Subject: 27 Bellevue Avenue, Avalon Beach NSW 2107 DA 2020/1162 WRITTEN
SUBMISSION: LETTER OF OBJECTION Submission: Wise

Re:
27 Bellevue Avenue, Avalon Beach NSW 2107
DA 2020/1162

Demolition of existing building and associated structures the construction of Seniors Housing under SEPP (Housing for Seniors or People with a Disability) 2004, at No. 27 Bellevue Avenue, Avalon Beach.

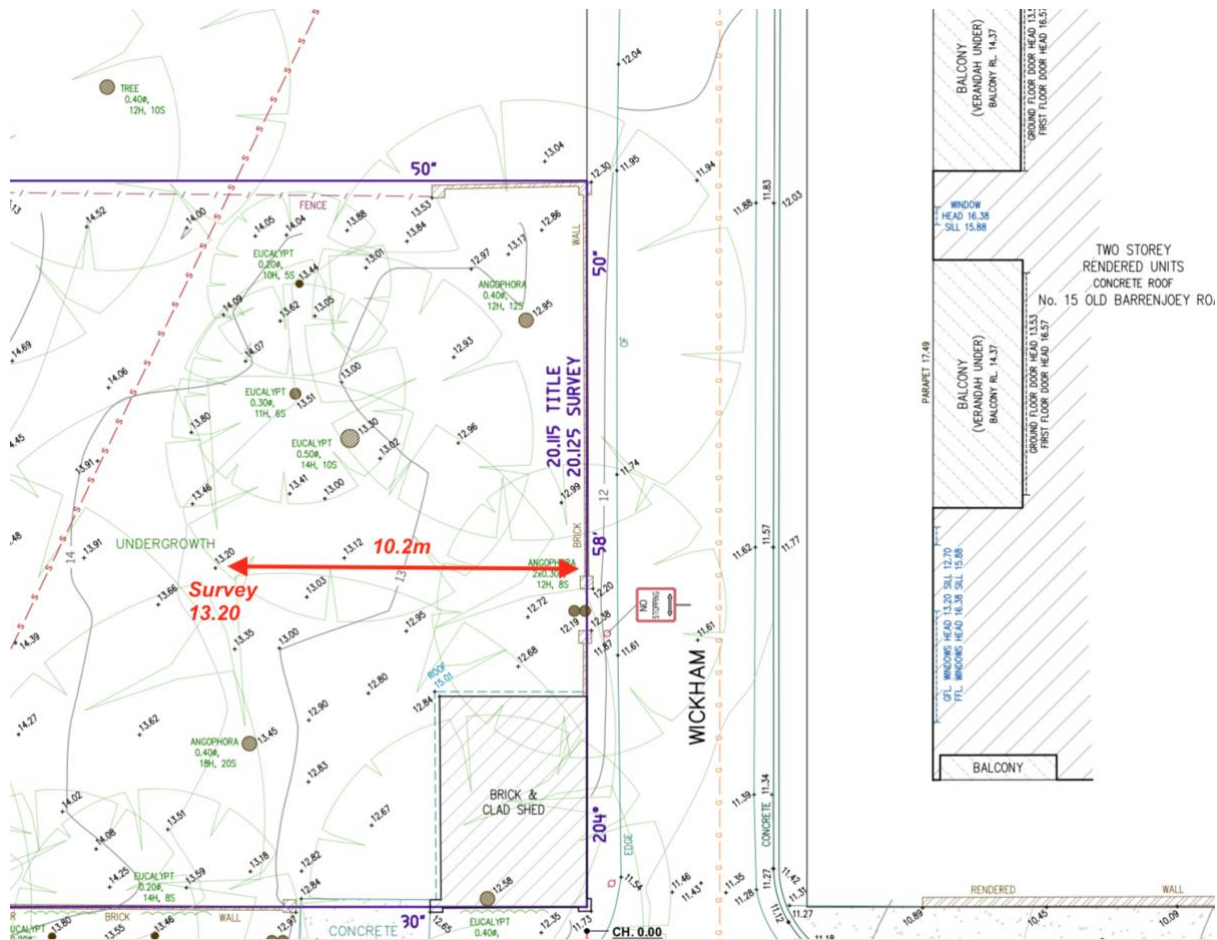
In this Submission I will contend that the proposed car park extends above ground by more than 1 metre, to a zone to a rear setback of 10.20m.

The proposed rear setback is just 3.25m, and therefore there is a substantial 313% non-compliance to SEPP HSPD controls.

The proposed Lower Ground Floor is at FFL 14.40, and a survey mark at 13.20 is positioned 10.2m from the rear boundary.

This represents a finished floor level 1.2m above this survey level, allowing for a 200mm slab.

I contend that as the proposed development is two storey in the rear quarter, then Council must impose a minimum rear setback of 6.5m.

It is my contention that the Lower Ground Floor must have a rear setback of 6.5m to better accord with Clause 40, and Control D1.9 of PDCP that provides that development in Avalon Beach on land zoned R2 Low Density Residential, R3 Medium Density Residential or E4 Environmental Living should have a rear setback of 6.5m.

1. Increase Rear Setback to 6.5m
2. Retain existing Trees in Rear Setback

3. Carpark to have a 6.5m Rear Setback
4. Landscape to fully cover the proposed development by dense vegetation screen facing Wickham Lane
5. Privacy Screens to windows facing Wickham Lane

DATE A	DATE 10/9/20	DESCRIPTION ISSUED FOR DA	PROJECT 27 BELLEVUE AVE (AVALON)	DATE NTS	DRAWING TITLE PHOTOMONTAGE 2	
			OWNER DA CLIENT CONSTRUCT BY DESIGN DRAWN BY SHED CHECKED BY SHED INCHES BY CH		DRAWING NO. 1901- DA 002 A

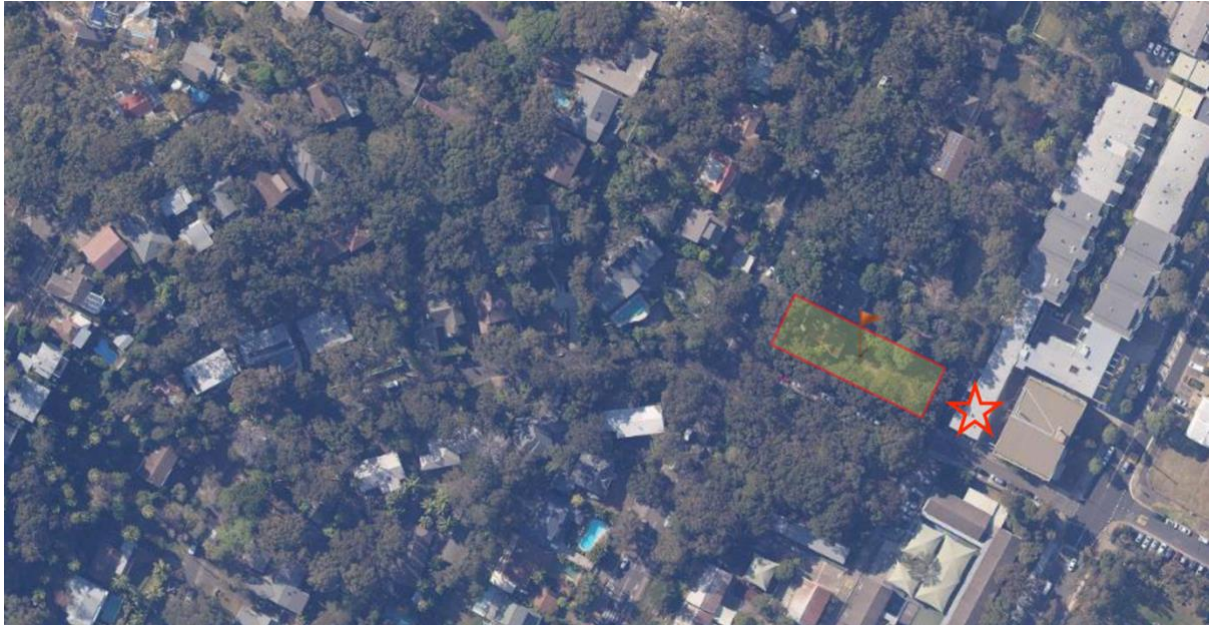
The Wickham Lane Montage clearly shows the unacceptable rear setback, and the removal of substantial trees in the DCP 6.5m rear setback zone. The rear setback does not accord with SEPP HSPD nor PDCP. Landscape is insufficient to screen the proposed building to Wickham Lane.
